SOLICITATION AMENDMENT
MODIFICATION DE L'INVITATION

Title - Sujet Reconst. Manège militaire Québec	
Solicitation No. - N° de l'invitation EE520-151410/B	Amendment No. - N° modif. 014
Client Reference No. - N° de référence du client EE520-151410	Date 2015-02-26
GETS Reference No. - N° de référence de SEAG PW-\$QCM-009-16291	
File No. - N° de dossier QCM-4-37219 (009)	CCC No./N° CCC - FMS No./N° VME
Solicitation Closes - L'invitation prend fin at - à 02:00 PM on - le 2015-03-12	
F.O.B. - F.A.B. Plant-Usine: <input type="checkbox"/> Destination: <input checked="" type="checkbox"/> Other-Autre: <input type="checkbox"/>	
Address Enquiries to: - Adresser toutes questions à: Thellend, François	Buyer Id - Id de l'acheteur qcm009
Telephone No. - N° de téléphone (418) 649-2889 ()	FAX No. - N° de FAX (418) 648-2209
Destination - of Goods, Services, and Construction: Destination - des biens, services et construction:

AMENDMENT 014

1) Questions and answers #453 to 517.

Question 501

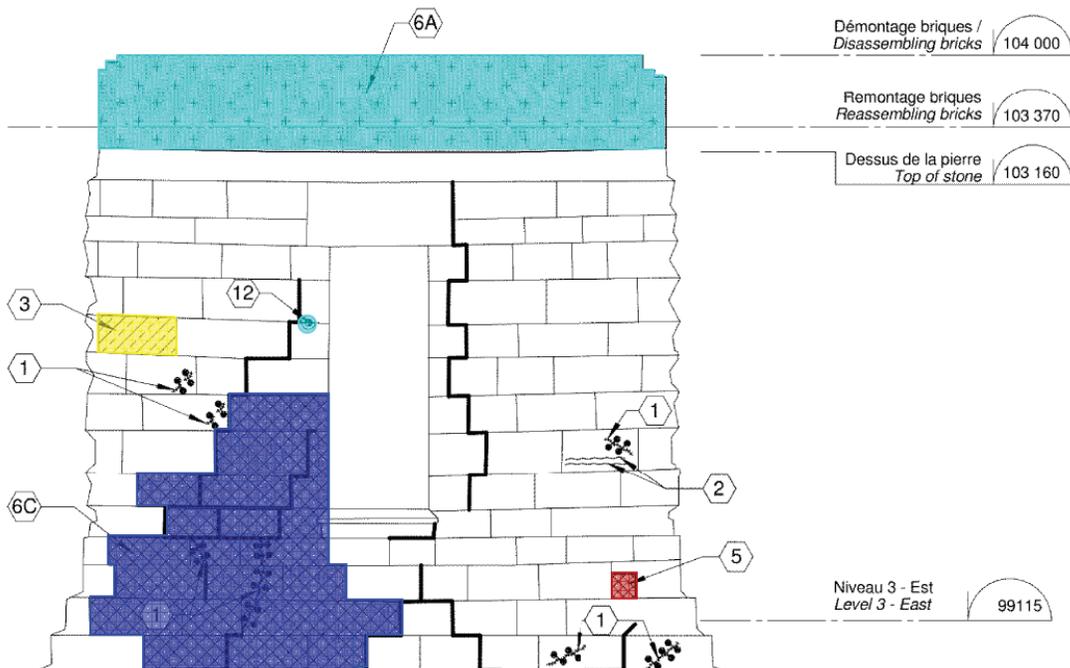
We are currently establishing masonry quantities. On several exterior elevations, we see thick lines resembling fissures. What work must be done on those lines? There is no indication in the legend. Is it the same work as for Note 2 on the *Legend of Exterior Interventions*? (See below.)

The bold lines shown on the exterior elevations of series A-500 are cracks as an indicative information. All diverse masonry interventions shown on the drawings as mortar joints repointing, stone repairs, masonry dismantling/rebuilt are to address the sources of the cracking and fissures.
